Planning Commission Agenda
May 17, 2023

RE: Hillsdale College Sajak Media Center Site Plan Review

Plans for the proposed Sajak Media Center Building for Hillsdale College located at 111 E Fayette St. were reviewed by the City Dept. Heads on May 3, 2023. Their comments are as follows:

RE: Hillsdale College Classic Education Building Site Plan Review

SITE PLAN

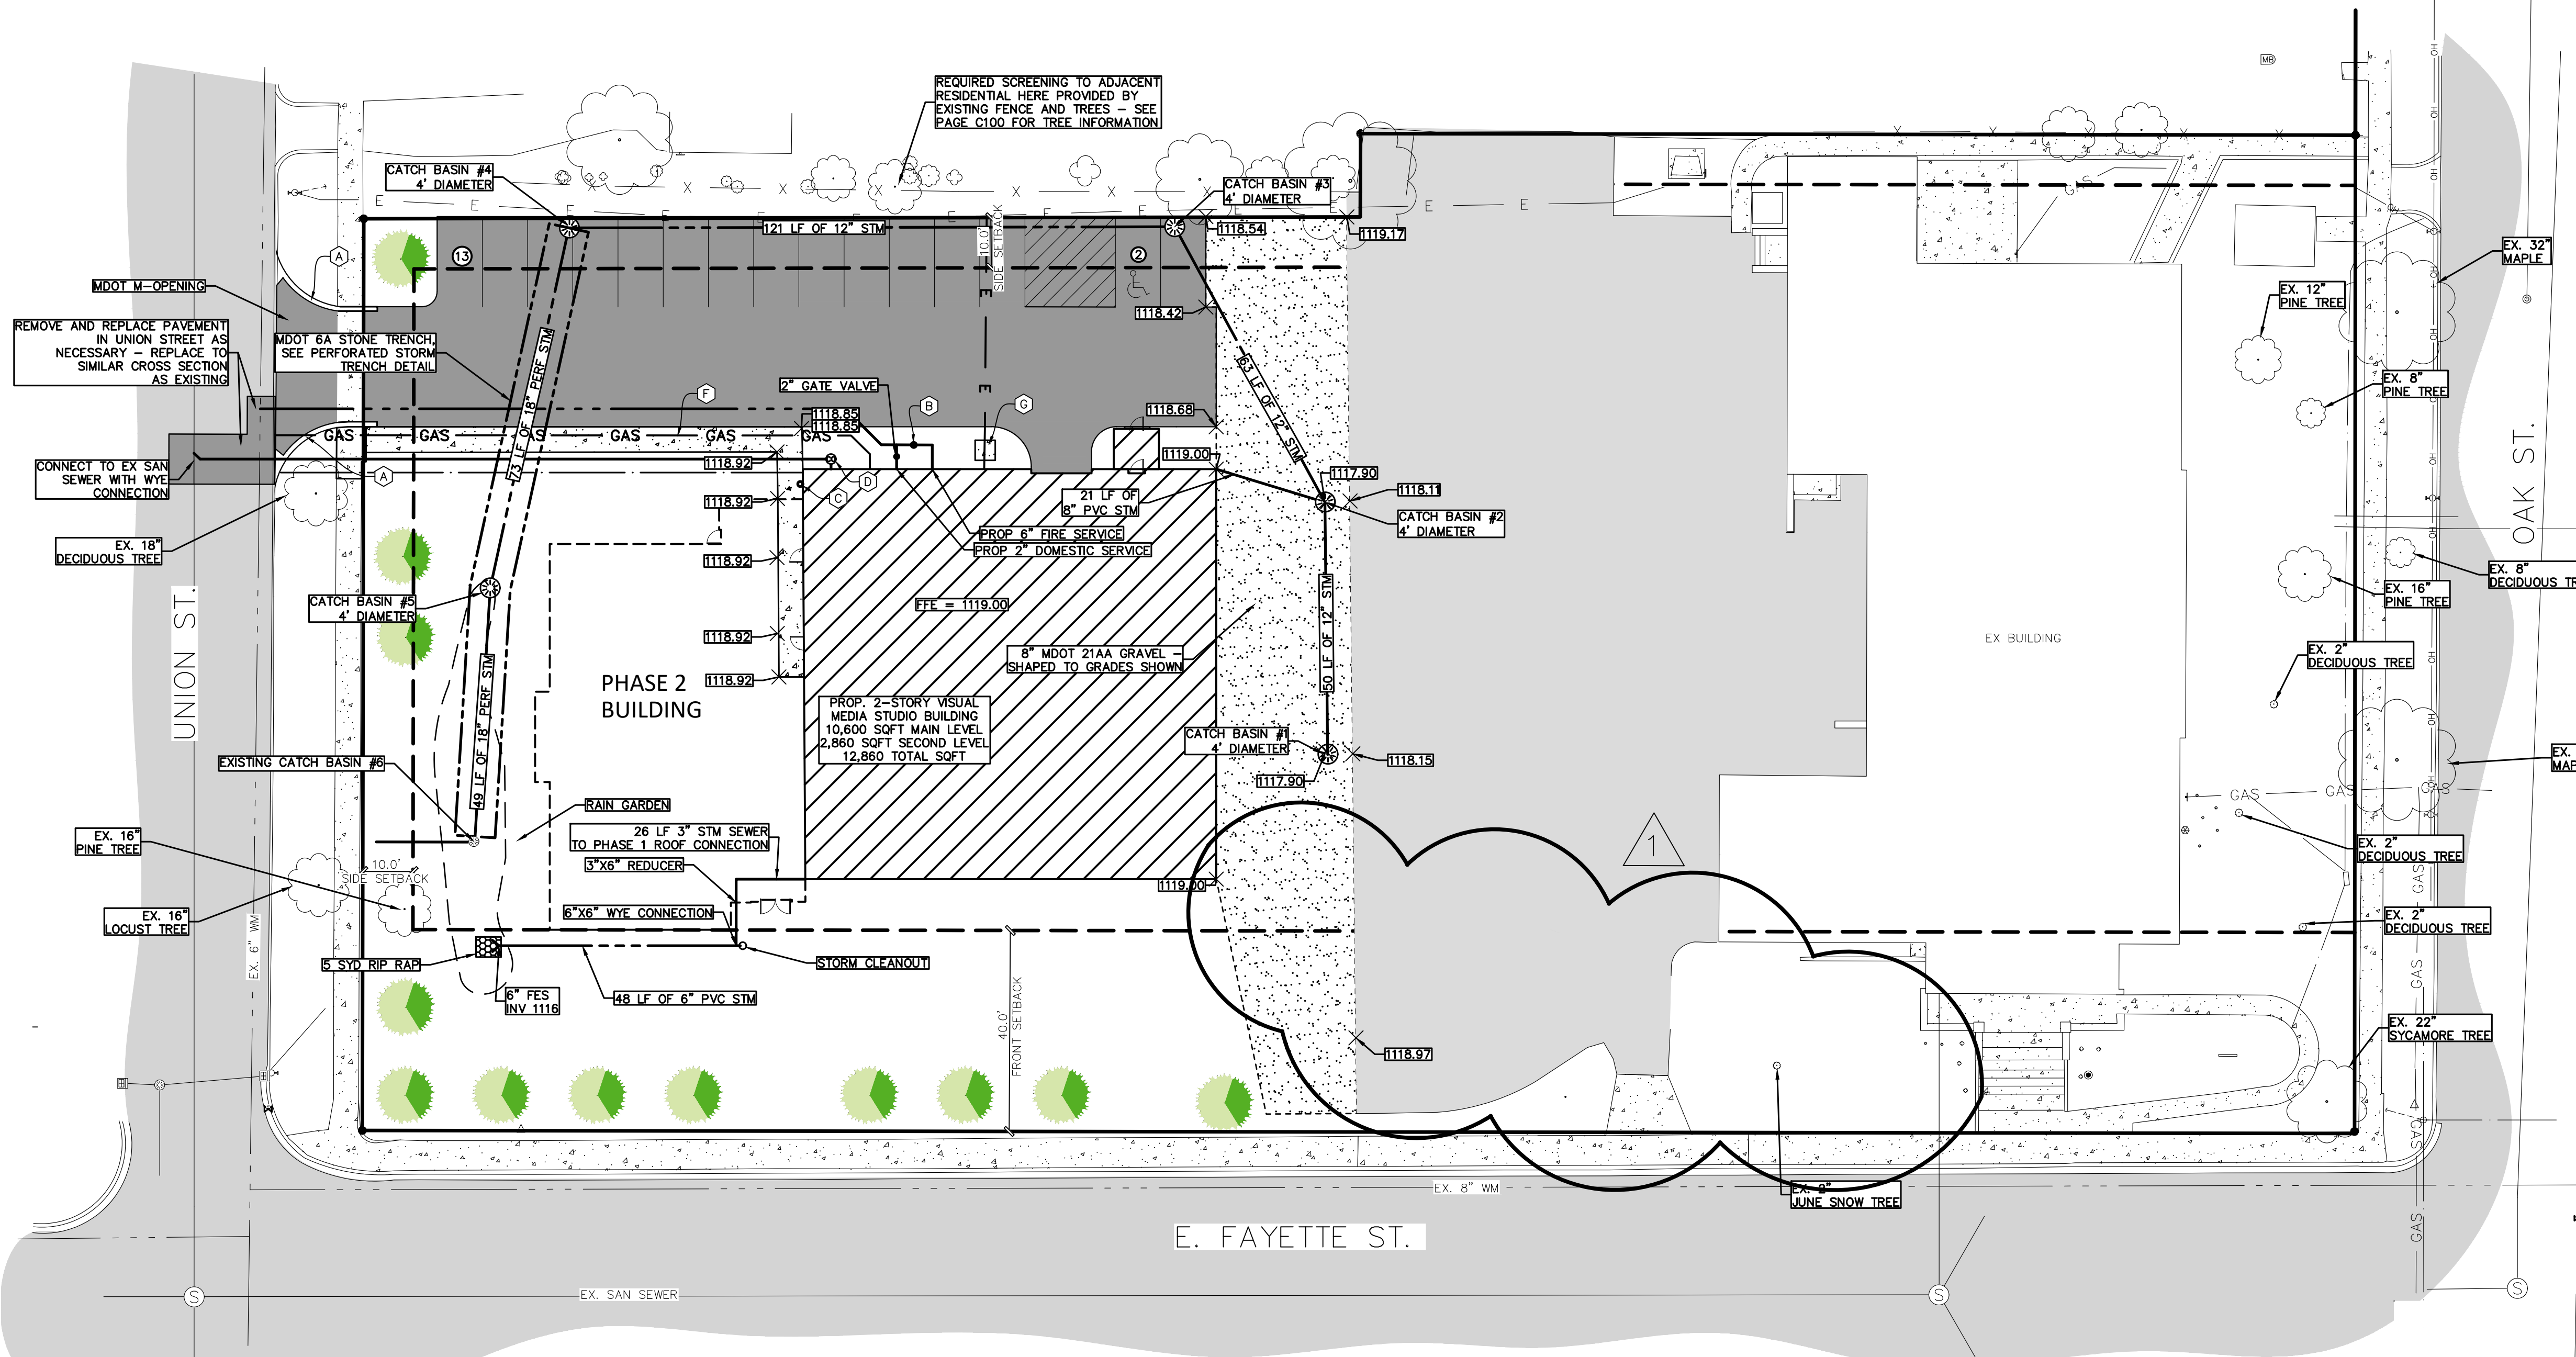
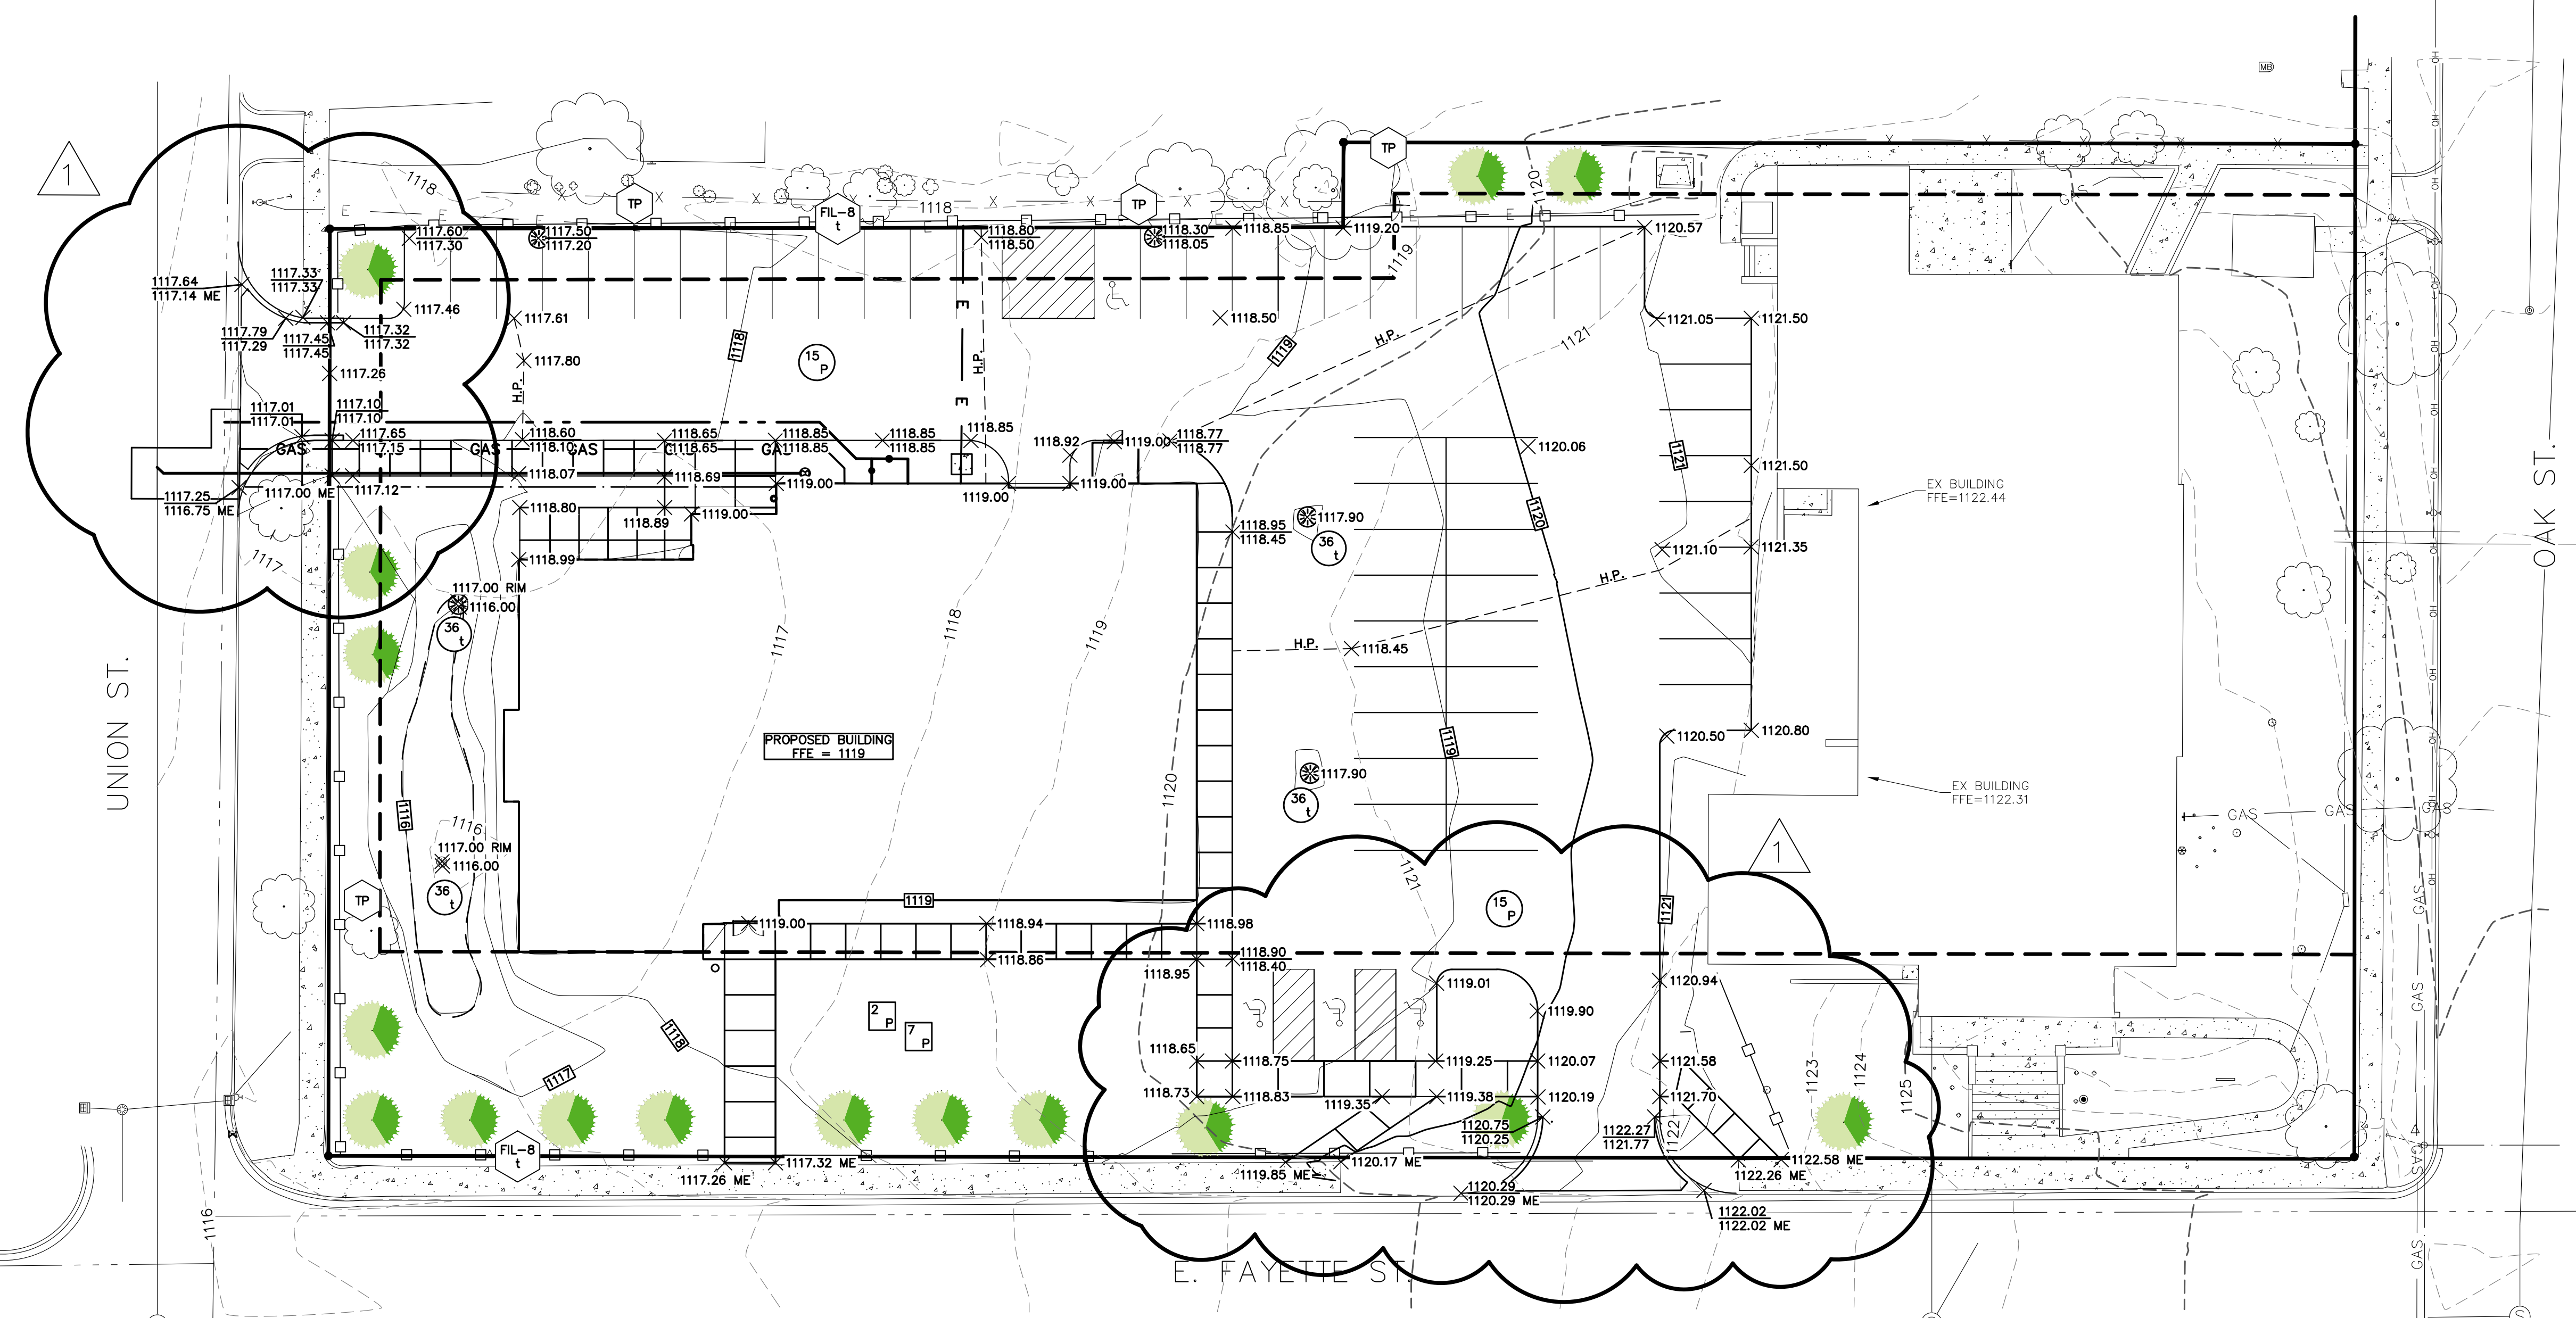
- Requested that the FDC be 2 ½”.
- Would prefer the FDC be located on a wall facing a street. The proposed location is 105’ away from the nearest street.
- No perimeter fencing is proposed for the project that would inhibit building access during a fire.

- Electrical:
 - Requested electrical plans from architect to verify load amounts
 - New building will require 3ph power, existing 3ph is located on west side of Union St.
 - Proposed bringing new service to pedestal junction box directly north of new building transformer and then feed under proposed parking lot.
- Water
 - No issues.
- Sanitary
 - Connect new building sanitary to existing 8” clay under Union St.
 - Field verify depth of existing sanitary.

- Request that errors in notes be fixed.
- Add geo-tech fabric to top of detail to prevent soil infiltration.

- Change curb/gutter detail from F2 to F4 curb style as existing street curb is F4 style
- Project parameters should include replacement of any broken sidewalk within project scope.
- Sidewalk at Fayette St. drive opening should be moved to the north to avoid being located in turning radius.

- Dimension needed in the proposed parking lot.

- MDOOT F4 CURB AND GUTTER
- GLOW INDICATOR POST STYLE 2945A SIZE C TELESCOPING BARREL 10.7M
- FDC = DOUBLE 2.5" CONNECTION
- SANITARY SEWER CLEANOUT
- CONCRETE TURN DOWN EDGE
- CONTRACTOR TO COORDINATE PRIVATE UTILITY CONNECTIONS WITH APPROPRIATE UTILITY AGENCY (GAS, AND COMMUNICATIONS)
- ELECTRIC TRANSFORMER

DRAWING TITLE:
SITE LAYOUT GRADING & UTILITY PLAN

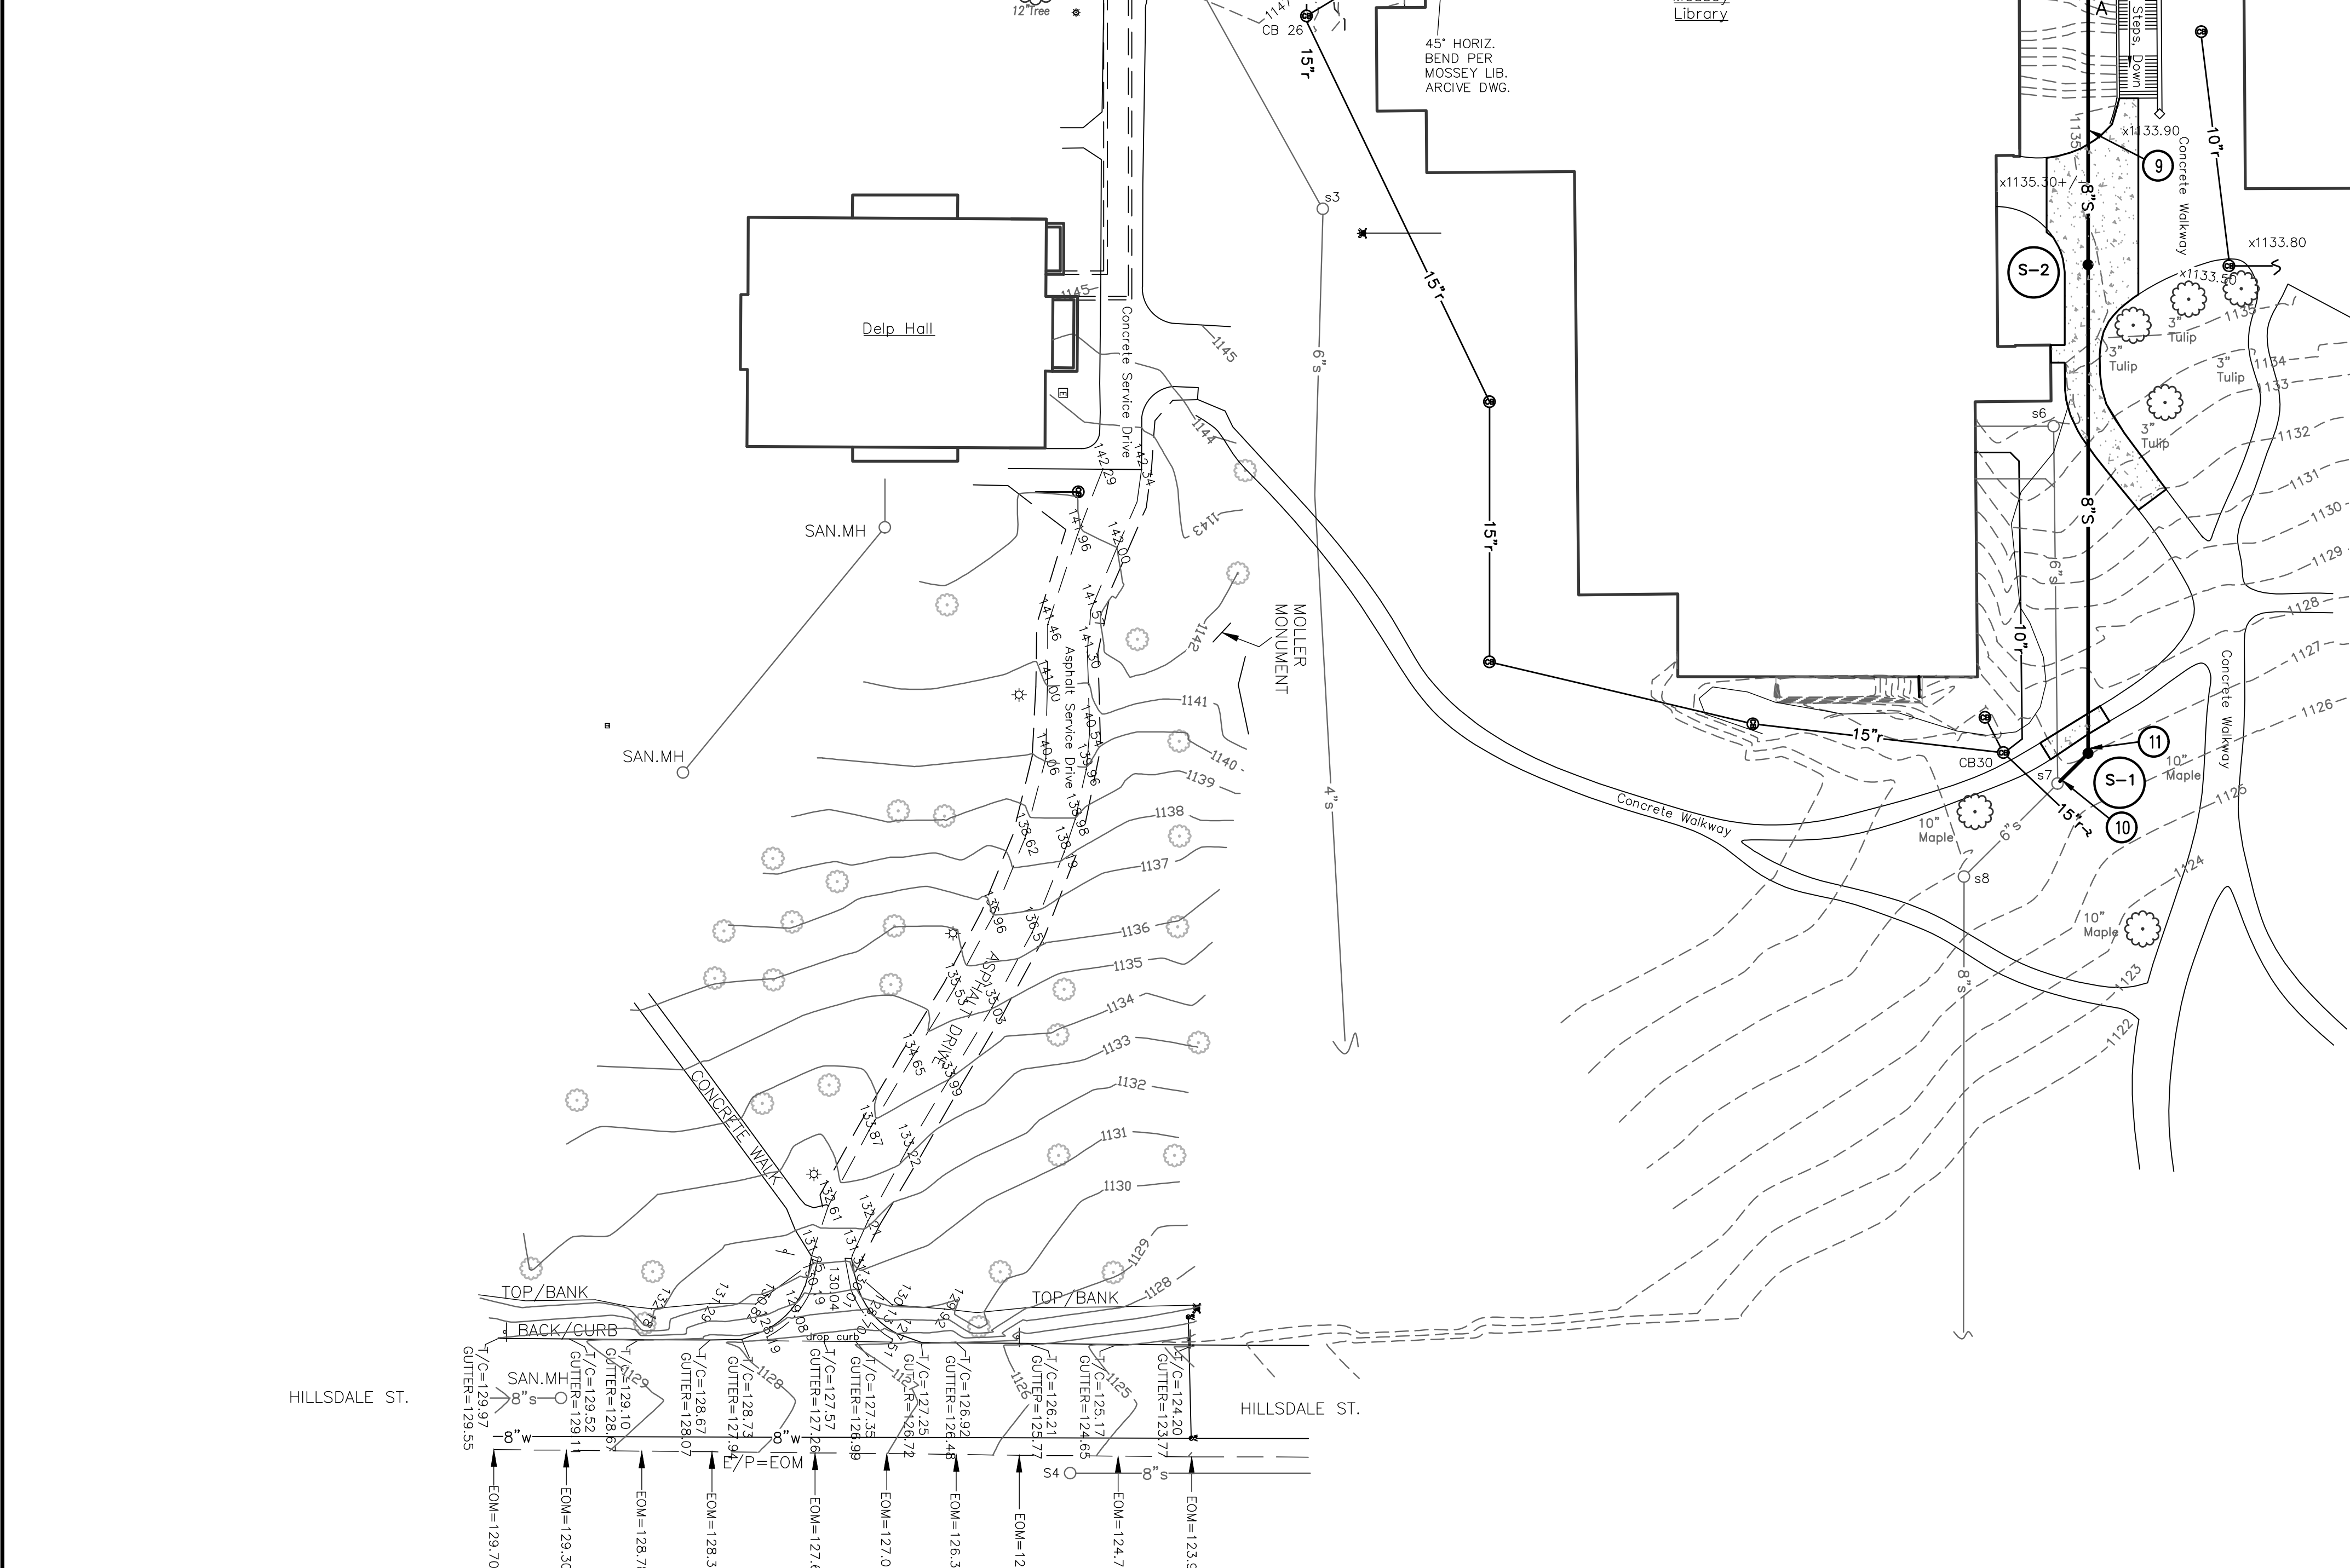
- Verify CB 18, 19 & 22 are 15" RCP.
- Key notes need to be reviewed and corrected.
- Storm Schedule
 - Call out sheet number referenced.
- Suggested reroute of storm not to avoid future library building expansion. (CB 24 thru 26)
- Revise detail of underground detention chamber.
